December 31, 2025

RE: Comments on the Visual Impact
Assessment for Ancram Solar

Attachment: Comments on simulations and viewshed maps

Photosimulation – View 1

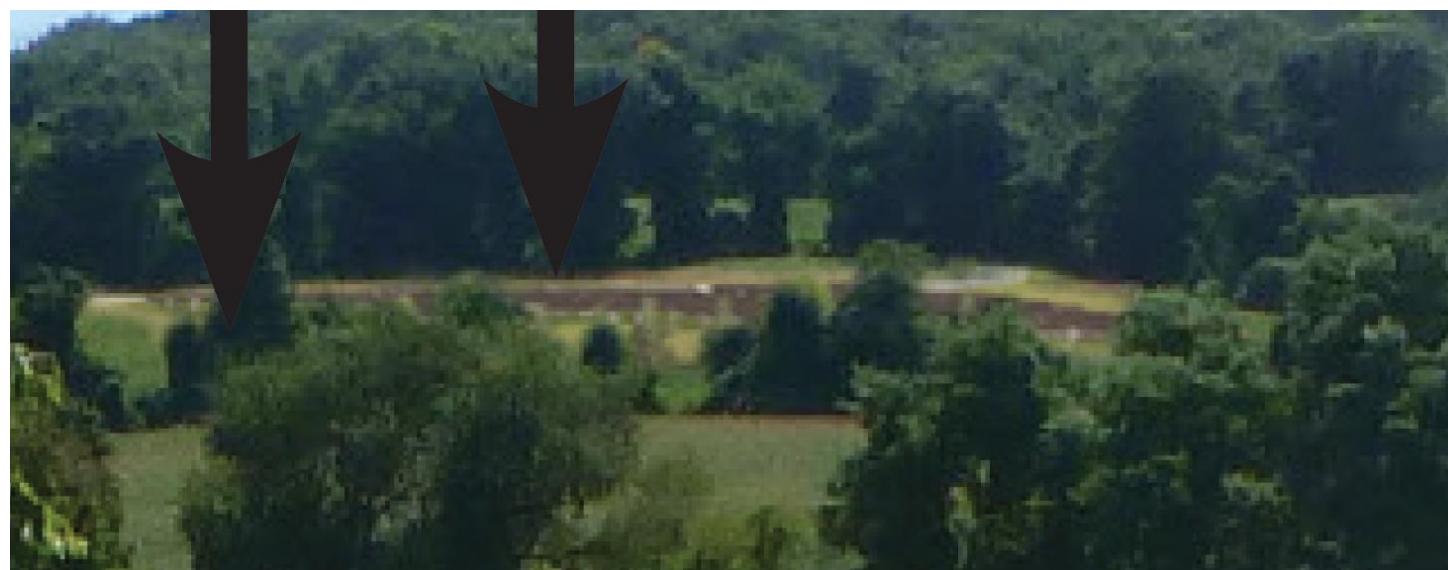
1. The existing conditions photograph is taken during leaf on conditions.
2. There is no meaningful information about the date/time of the photograph and the lens of the camera used
3. The tree in the foreground could have been avoided if the photograph would be taken from the other side of State Route 82 or a few feet down the State Route 82
4. There will be more visibility during leaf off conditions from the existing vegetation
5. The notation on the simulation interferes with the ability to understand and use the simulation to evaluate the change the project brings
6. There will be significantly more visibility if the photosimulation was done with no landscape mitigation or at the time of planting

Photosimulation – View 13

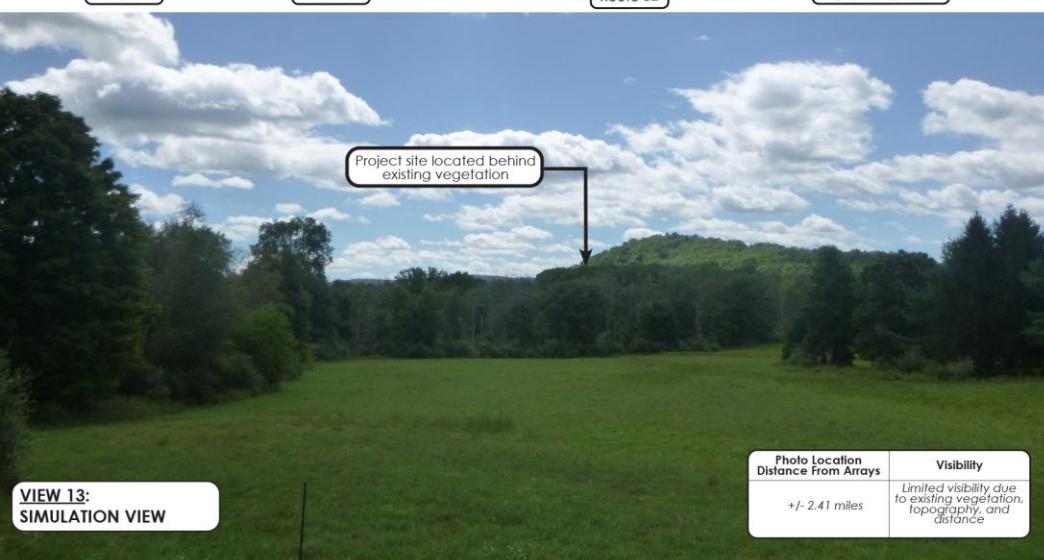
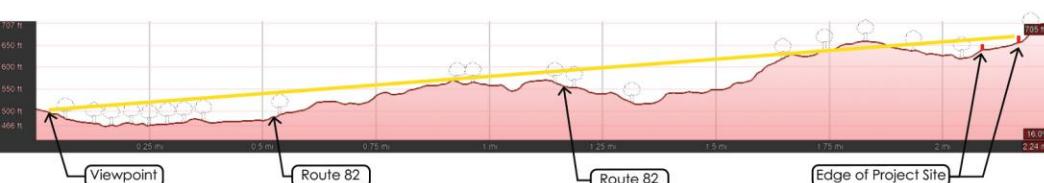
1. The existing conditions photograph is taken during leaf on conditions
2. There is no meaningful information about the date/time of the photograph and the lens of the camera used
3. The photograph has high contrast / pure exposure, which is not ideal
4. Illustrative trees shown on LOS profile are not correctly scaled
5. LOS profile obscures part of existing conditions photograph making a direct comparison impossible
6. LOS profile suggests topography blocks the view, while the annotation states that existing vegetation limits visibility
7. Annotation on the image interferes with the understanding of the image. If an image needs to be explained, it can be explained with an additional image showing annotation

Ancram Solar
Viewshed Analysis-
Project Parcel
3333 NY-82
Ancramdale, NY 12503
SBL: 214-1-25.4

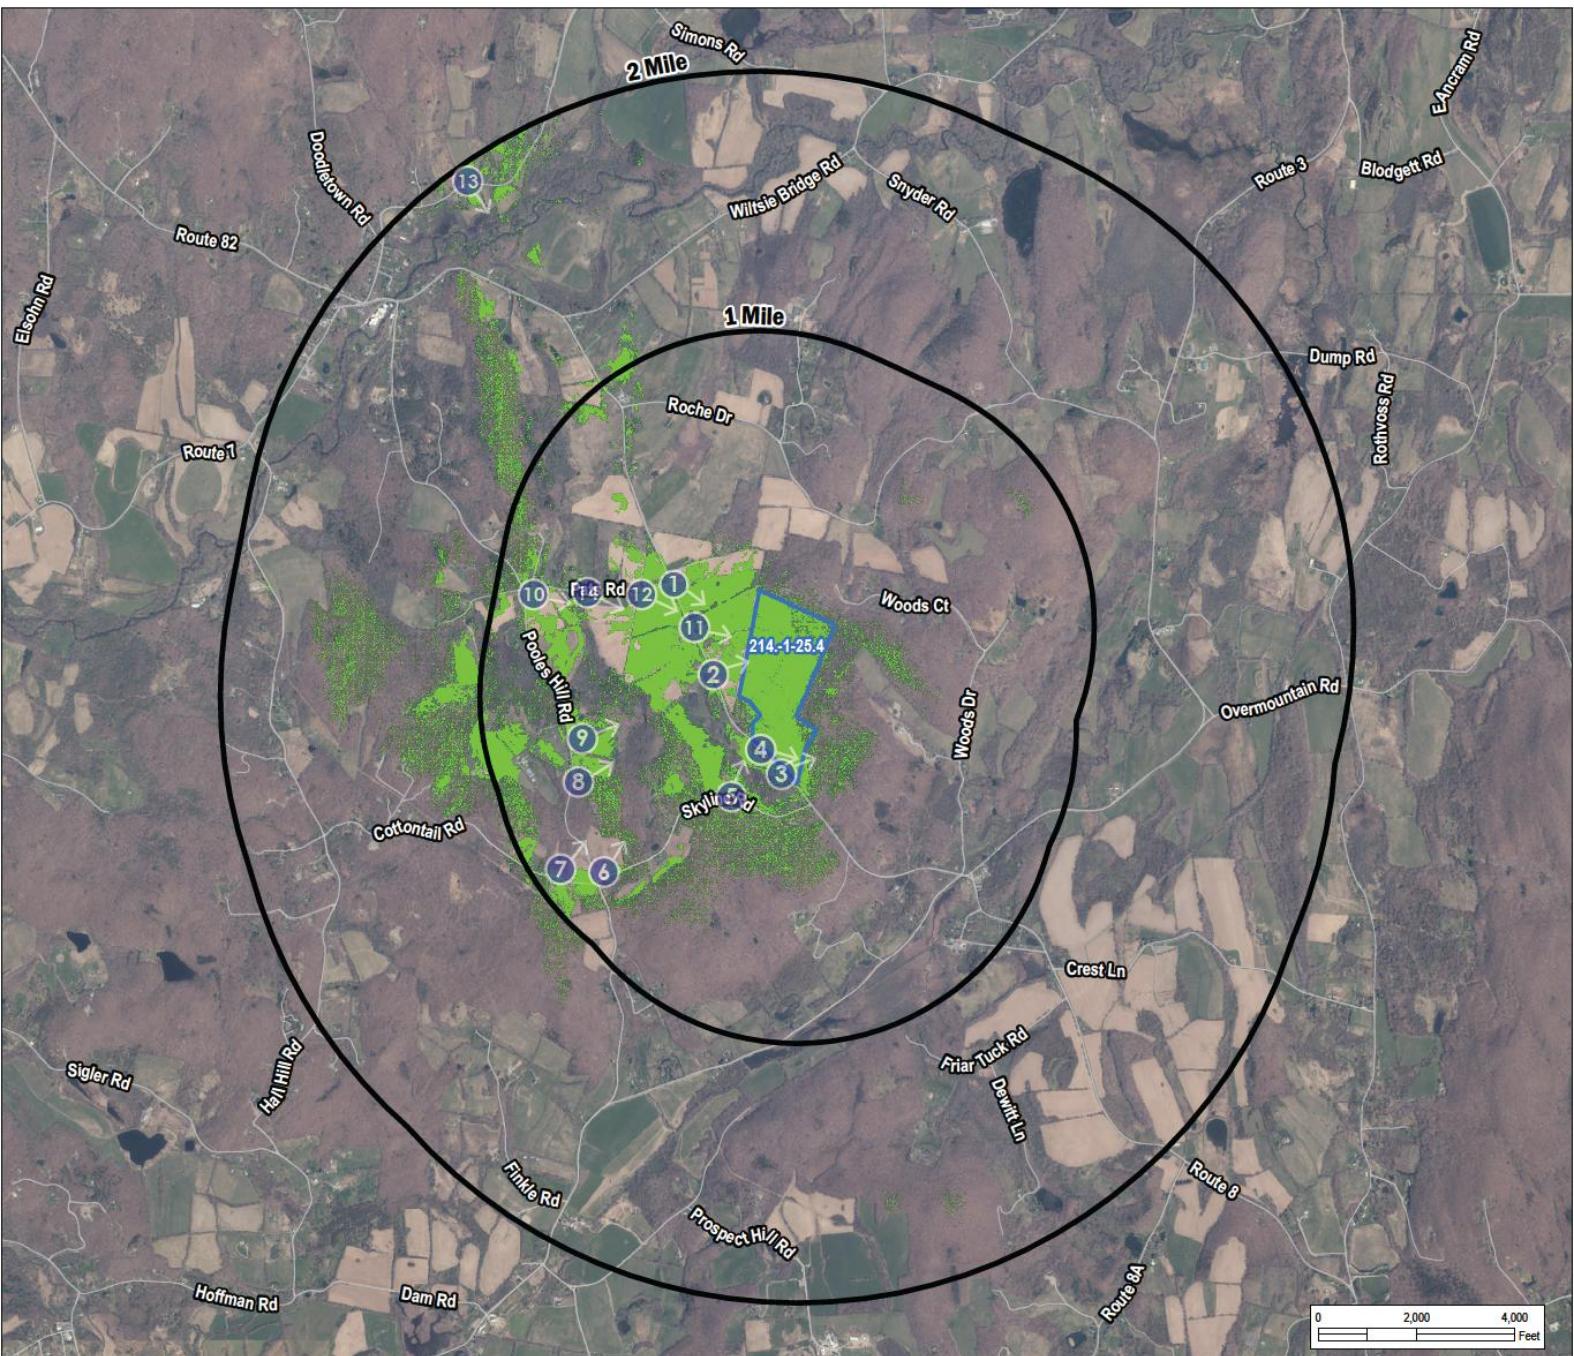
- Viewshed analysis shows visibility on wooded areas, which indicates the viewshed is only done with elevation features (DEM). DSM would have likely produced different results
- There are no visual resources shown on the viewshed map. The VIA does not describe if there are any within the map extent
- The viewshed color is not clearly distinct. The underlying aerial imagery and viewshed's green shades are not easy to distinguish
- 1- & 2-mile radius area seem to be based on the parcel not from area of disturbance
